Access Compliance Report

Public Rights-of-Way

(Curb Ramps)

Intersection ID: 32248	Main Street: DENNINGTON GROVE LN	Cross Street: WESTGARTH AV	Location: E
ADA ID: 2A21CB479B1C	Ramp Type: BlendTrans1	Initial Pass/Fail: Pass	Overall Compliance: No
Severity Score: 15			
Codes/Mitigation Info/Possible Solution		Field Measurements/Component Compliance

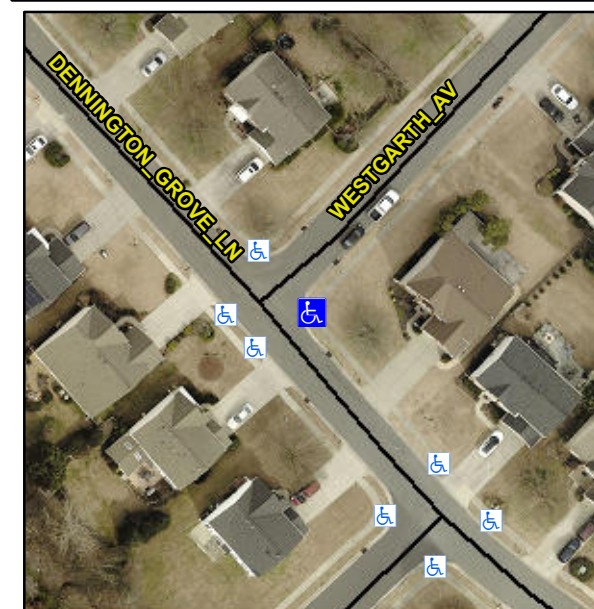
Not Found, R304.2.1, R305, R304.5.4

Remove & Replace Curb Ramp With Two New Directional Ramps or Equivalent. Remove & Replace Gutter.
